**Coachmen**<sup>®</sup>  
RECREATIONAL VEHICLE COMPANY

**RE:** Safety Recall 99V-076

QUANTITY	REF NO.	PART NO.	MATERIAL OR PART DESCRIPTION
			CLASS CODE: 00990
TOLERANCE UNLESS OTHERWISE SPECIFIED	DFTSN	DATE	COACHMEN R.V.
WOOD OTHER	SDH	4/26/99	SERVICE PROCEDURE, GROMMET
± 1/8" ± 1/16"	APPVD	DATE	SCALE
± .125" ± .063"			PART # 640201
USED ON			DO NOT SCALE DRAWING
			SHEET 1 OF 1

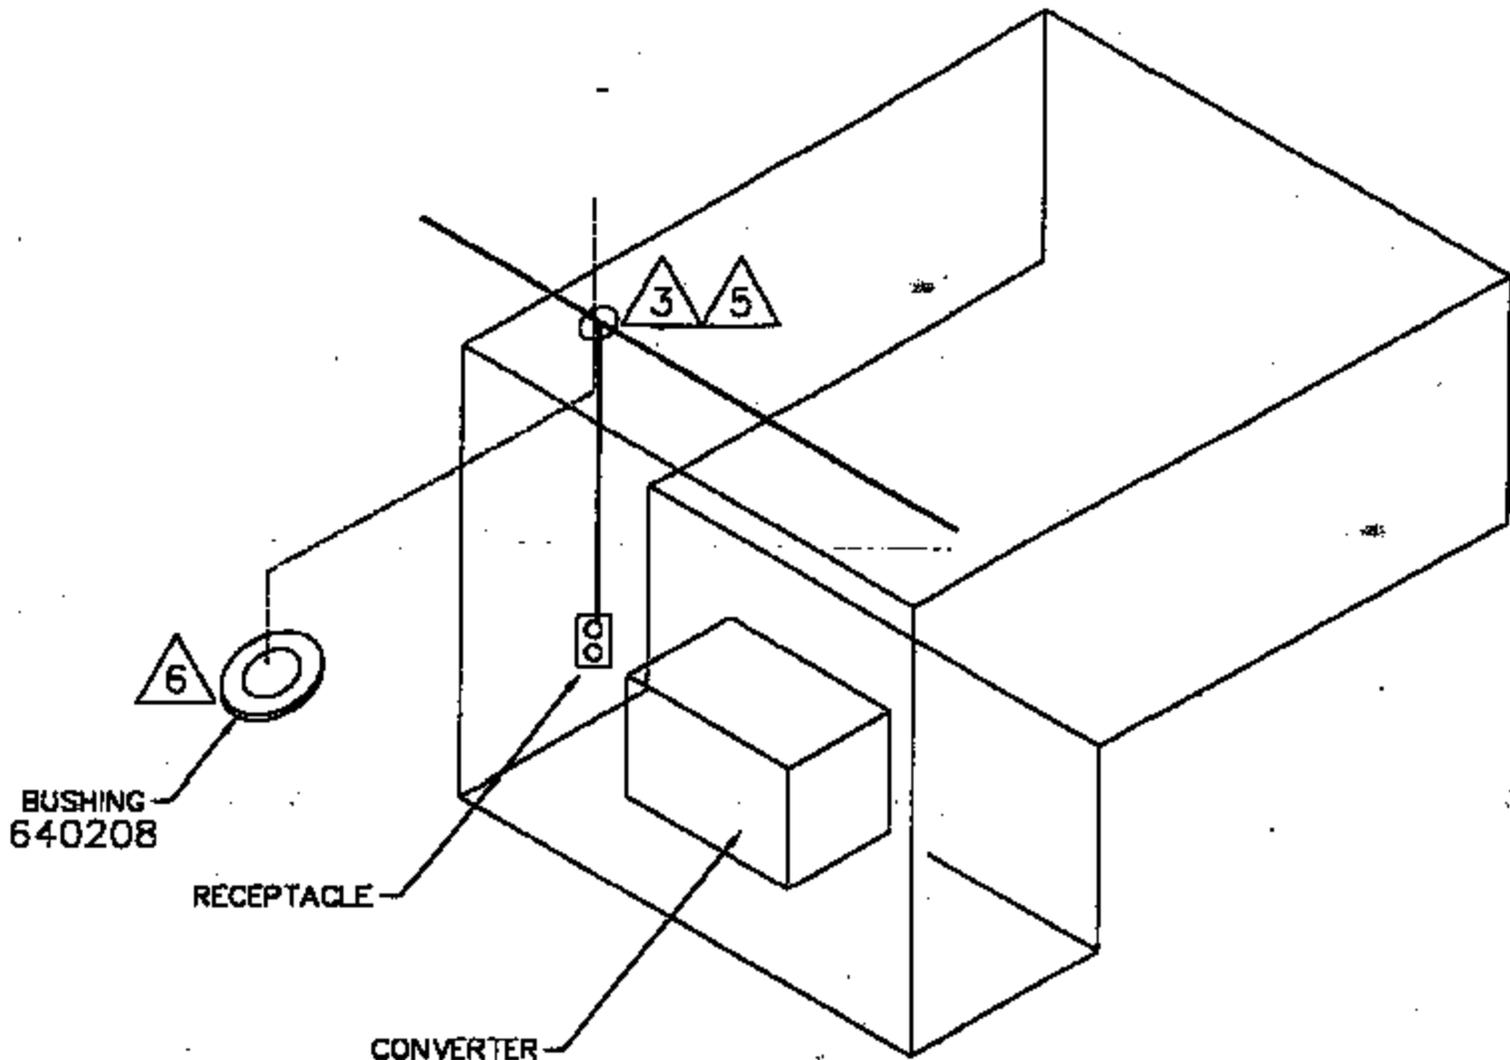
3) Follow the wires to the top of the compartment. Find the hole in the floor where the wires are coming down through.

4) Verify that the wires are protected with a plastic grommet or solid conduit that passes through the metal floor skin. The floor assembly only has metal on the bottom side.

5) Verify that the hole is sealed, if not seal hole.

6) If no grommet or conduit is found. Add a bushing plate (640208), to keep the wires away from the floor assembly metal.
